Submission - Casey Fields South (Employment) and Devon Meadows PSP

- The exhibition of draft Amendment C295case to the Casey Planning Scheme which implements the Casey Fields South and Devon Meadows Precinct Structure Plan (the Draft PSP).
- The Casey Fields South (Employment) and Devon Meadows PSP Drainage Strategy accompanying the Draft PSP (the Draft Drainage Strategy).

Figure 5: Jacobs Proposed Transport Network

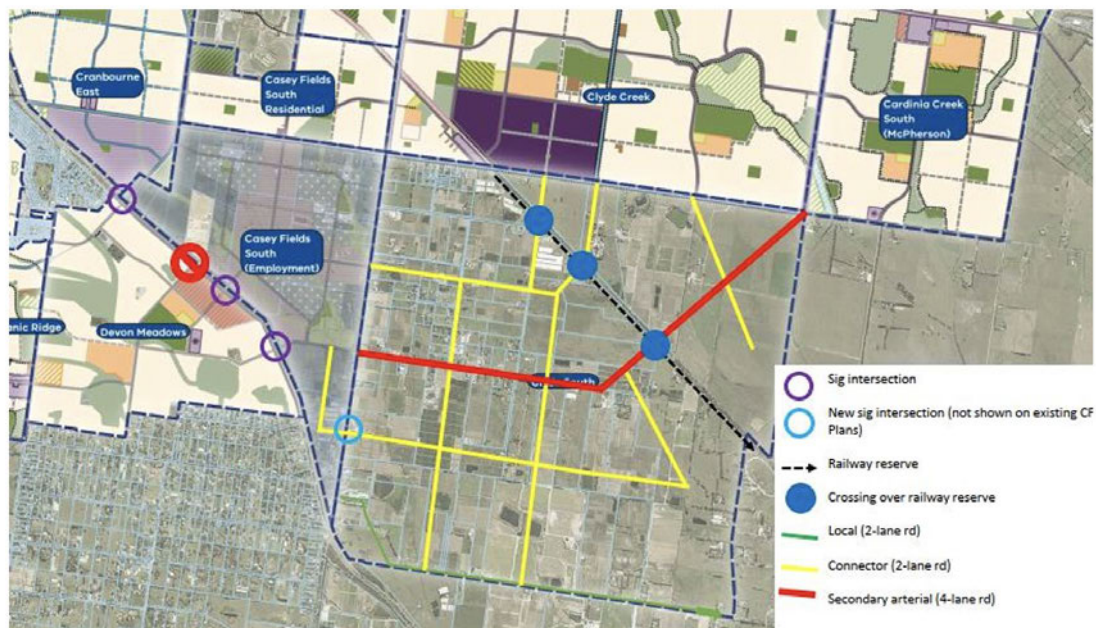
- The PSP rules out Moores Road from forming a connection from Bells Road in the north to the South Gippsland Highway as a secondary arterial road.

This is the network used in the Jacobs analysis for the PSP and shown in Figure 5.

ID_Land submits that the PSP road network prejudices the road network option shown in the Jacobs Report in Figure 5 being achieved. It does that without strategic justification and without testing the outcome of the PSP adopted road network.

- Explain the rationale for the adopted road network in terms of its implications for the Clyde South PSP. The PSP appears to have recently adopted the change without evidence that its implications have been adequately tested.
- Ask Jacobs to test several road network scenarios, including the PSP road alignment which deviates Clyde Road as shown in the PSP. That analysis should be made available to Council and interested landowners.
